From: [Richard Thesing](#)
Cc: [Adrienne Smith](#); [Jon Biggs](#); [Catherine C. Engberg](#); [carter](#) [REDACTED] [Kevin Schwarckopf](#)
Subject: 4370 Alpine
Date: Tuesday, March 19, 2024 2:56:34 PM
Attachments: [A-1.1 Site Plan - Proposed Subdivision.pdf](#)

From: [Gina Dixon](#)
To: [Adrienne Smith](#)
Subject: Re: Draft Zoning Code and Zoning Map Amendments
Date: Monday, March 18, 2024 11:57:54 AM
Attachments: [Planning Commission Agenda_Marked Up Pages_Gina Dixon.pdf](#)

I have a few comments on the draft zoning amendment. I pulled out the specific pages with comments to make it easier, but if it's helpful to have it in a different format, please let me know.

Figure 18.04.077: Building Height, Maximum

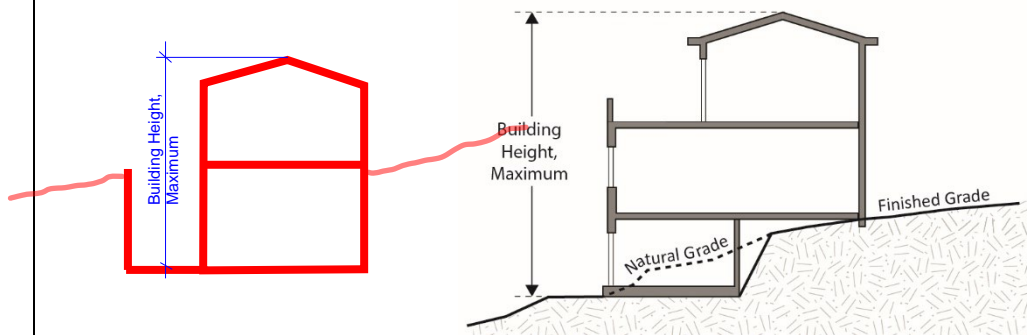
It would be very helpful to show a house with Basement and adjacent lightwell and show that maximum height is measured at the light well. *This is very atypical in municipalities in the area*

18.04.078 Building height, vertical.

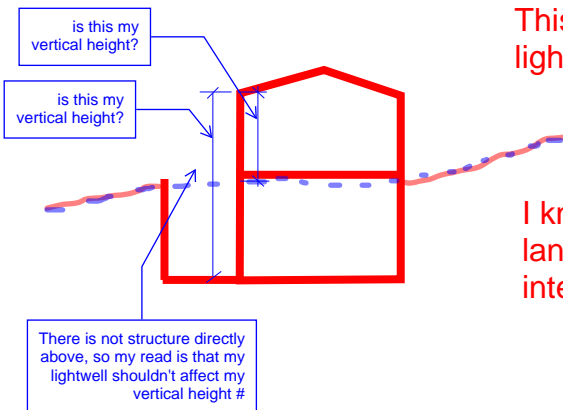
This is still unclear how vertical height is applied to a building with a lightwell because there is no structure directly above a lightwell...

I know this is specific to one of my projects, but I still think this language doesn't clear up the confusion. I don't know what the intent is here, so can't make a suggestion
